ADC PARKS & GREENSPACE ARBORICULTURE

PLANNING APPLICATION: M/88/15/T

ADDRESS: 8 Hadley Close Middleton on Sea PO22 6PG

BRIEF DESCRIPTION: Crown reduce & lift 2No. Oak trees by 1.5m

Figure 2 Positions of final cuts

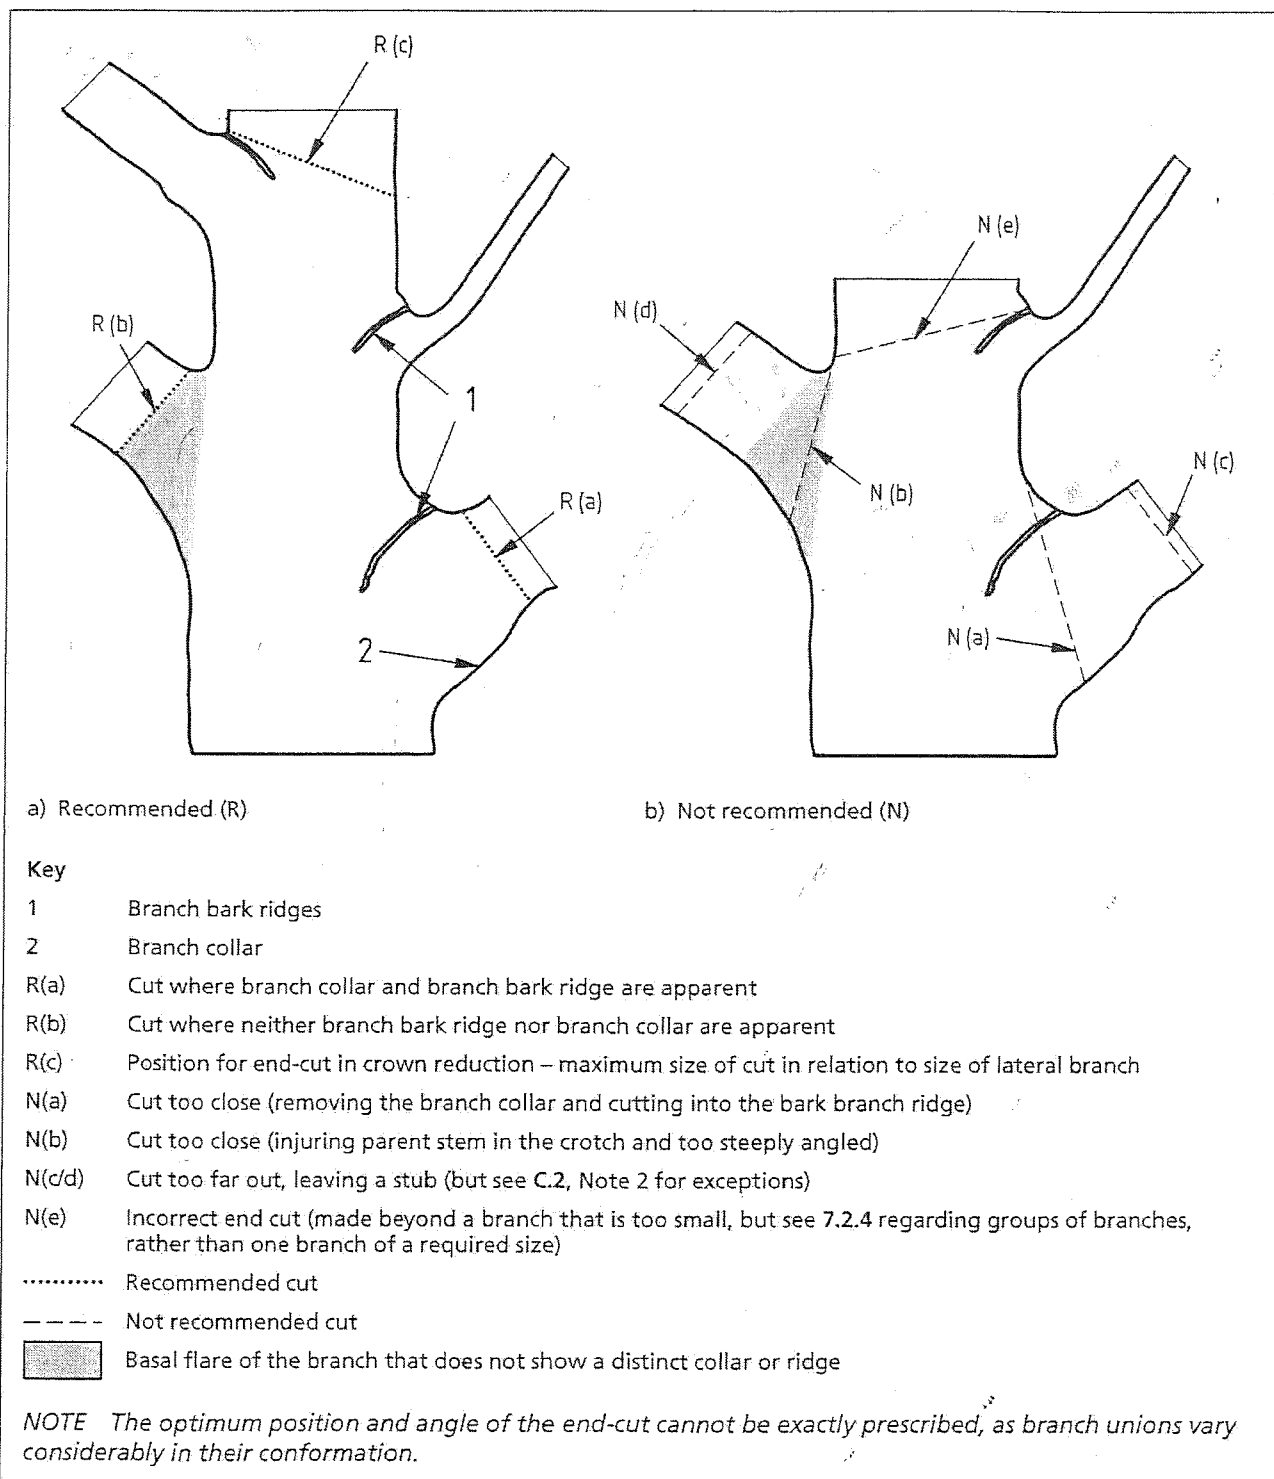
All side branches to be retained should be at least $\frac{1}{3}^{\text{rd}}$ in diameter of the removed branch. Pruning cuts must be flat and smooth, kept as small as possible by cutting at an optimum angle and should not exceed **100mm** in diameter.

Figure 4 Diagrammatic illustration of crown reduction

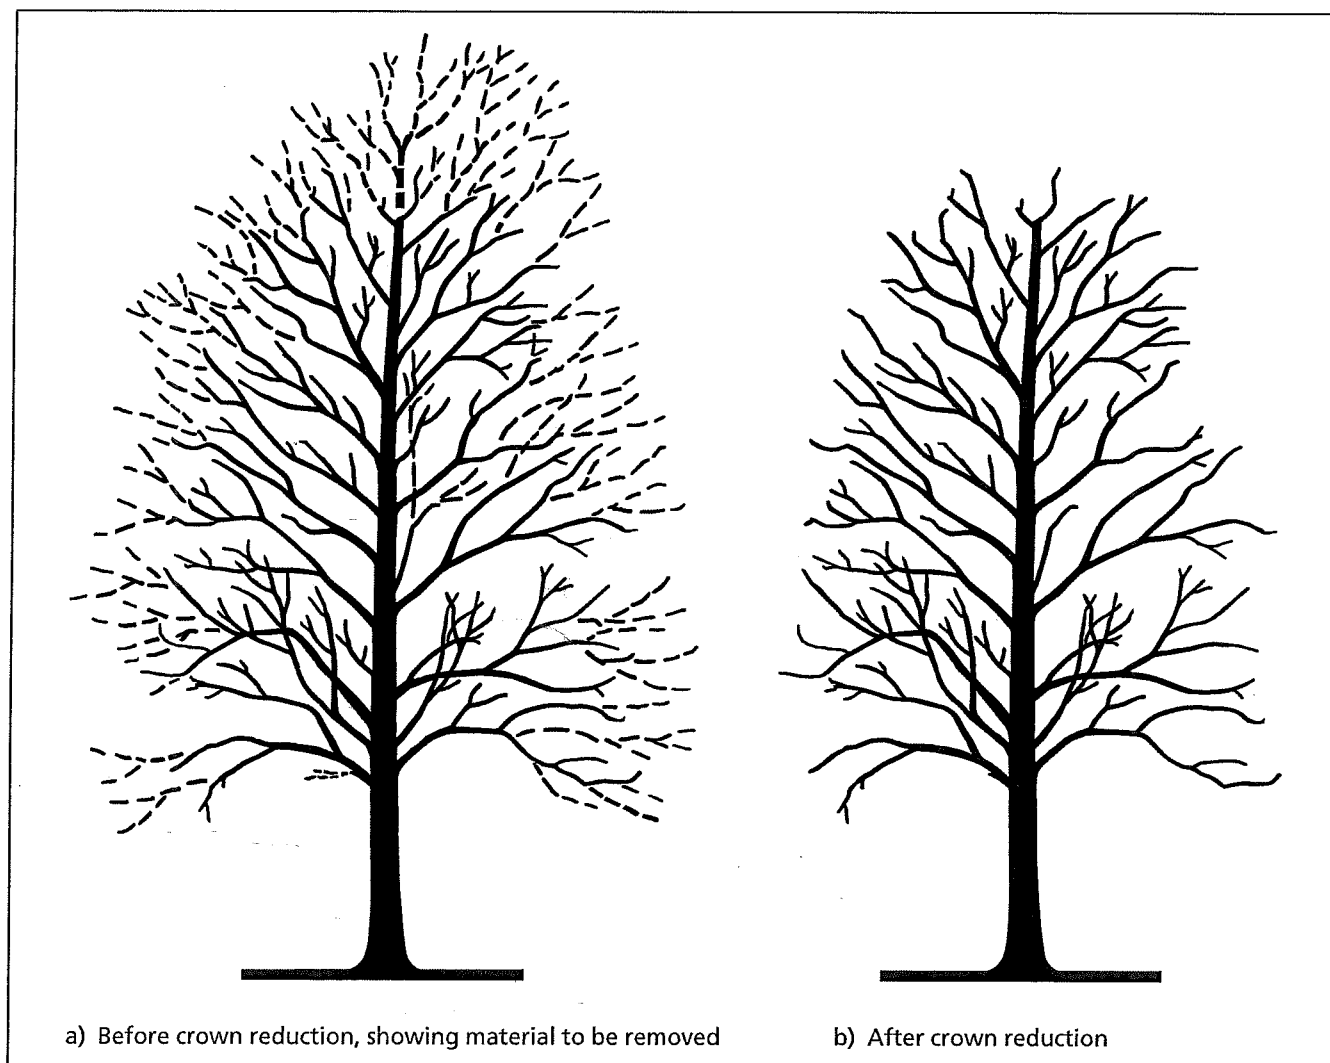
- I would have no objection to the proposed operations of no more than a 2 meter crown reduction to the northern sections (areas spanning towards the neighbouring property) only of both T1 and to T2.
- The following conditions are to be adhered to when completing the proposed reduction operation.
